Brisbane Central Business District Bicycle User Group

This letter seeks your action to address a broad range of concerns in relation to the recently opened main cycling corridor through the Howard Smith Wharfs development precinct.

Kerb ramp at roundabout

Attachment 2 - BCC approved drawing showing kerb ramp not delivered

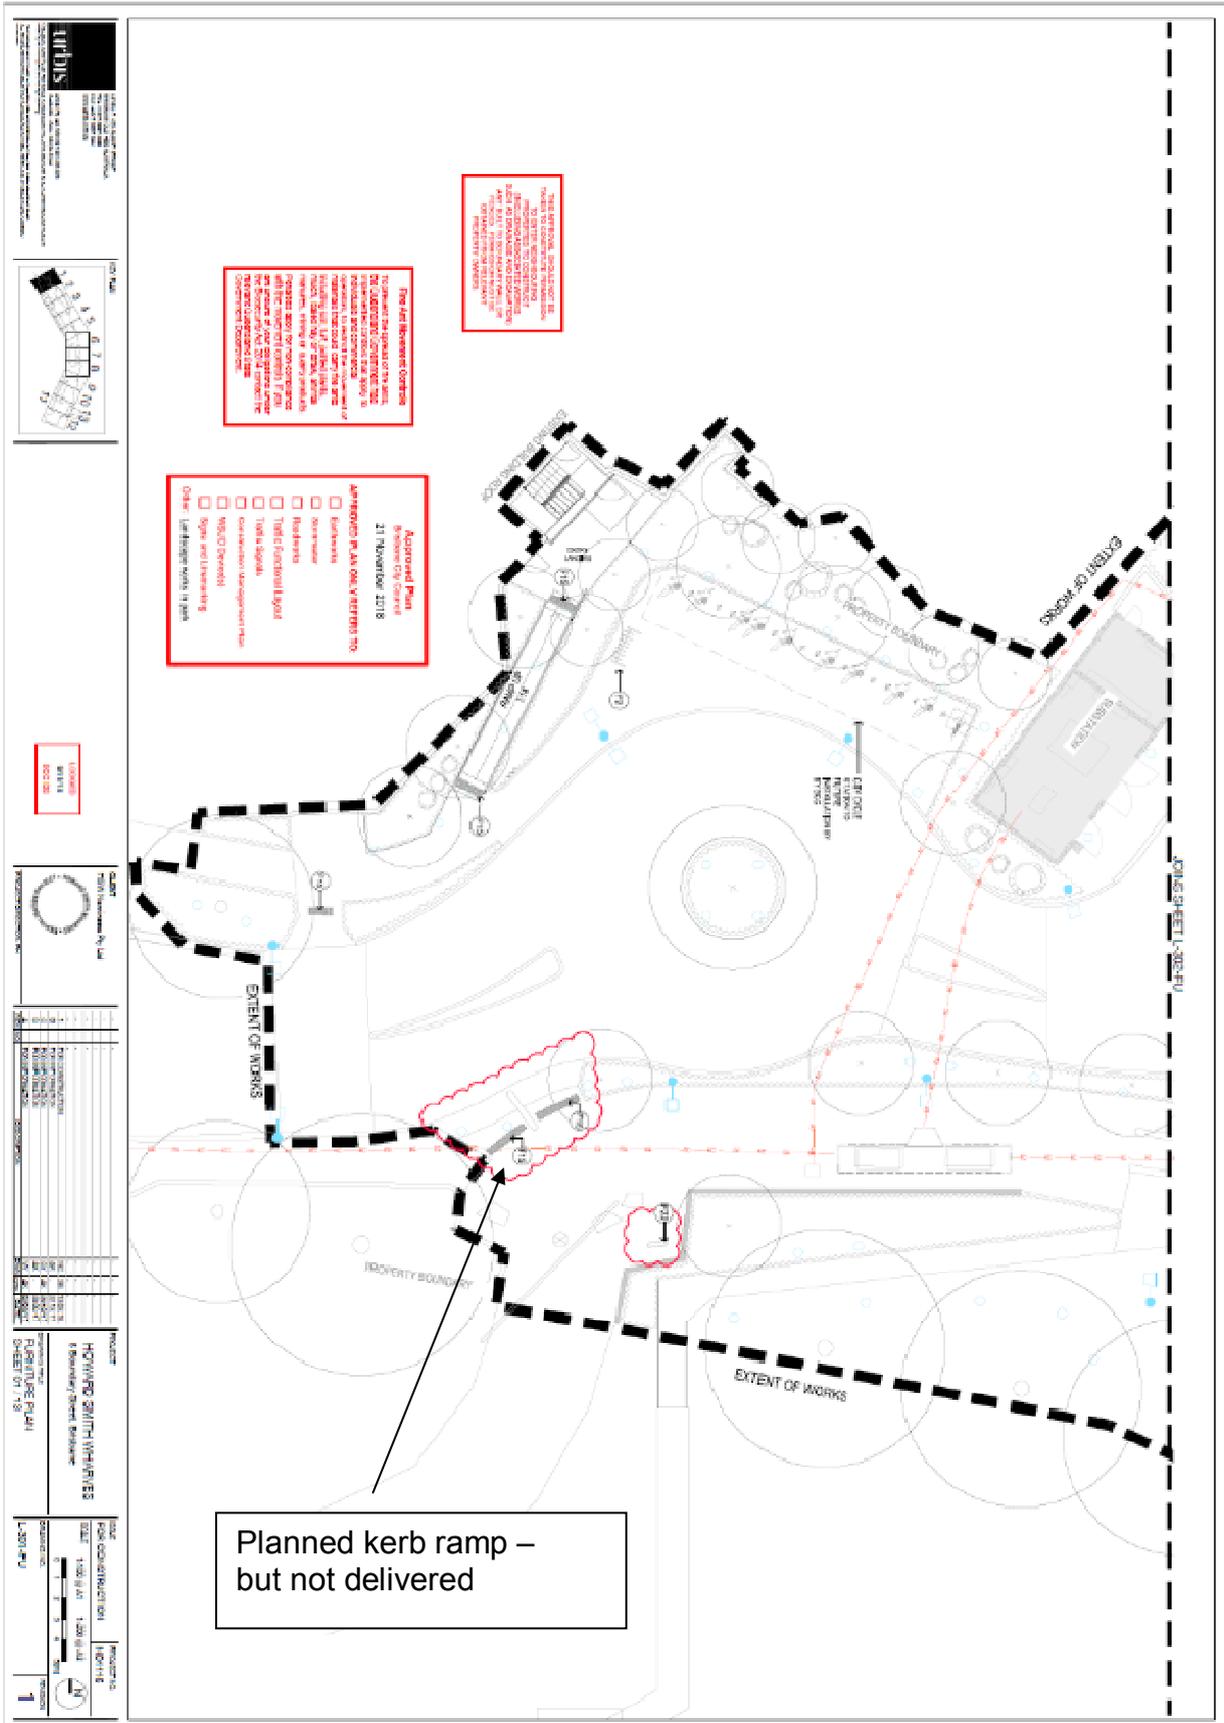
During the development application assessment process the CBD BUG indicated to Council that a kerb ramp should be provided where the City Reach Boardwalk meets Boundary St; and the CBD BUG was pleased to see this later feature incorporated into the development plans. Under application A0085062192, Sheet L301-FU, approved by BCC 21/11/18 (Attachment 2) it clearly shows a kerb ramp at this location. Therefore, the CBD BUG would like to enquire why this kerb ramp has not been constructed, as it would allow the free movement of bicycle rider traffic between the Story Bridge and the City Reach Boardwalk.
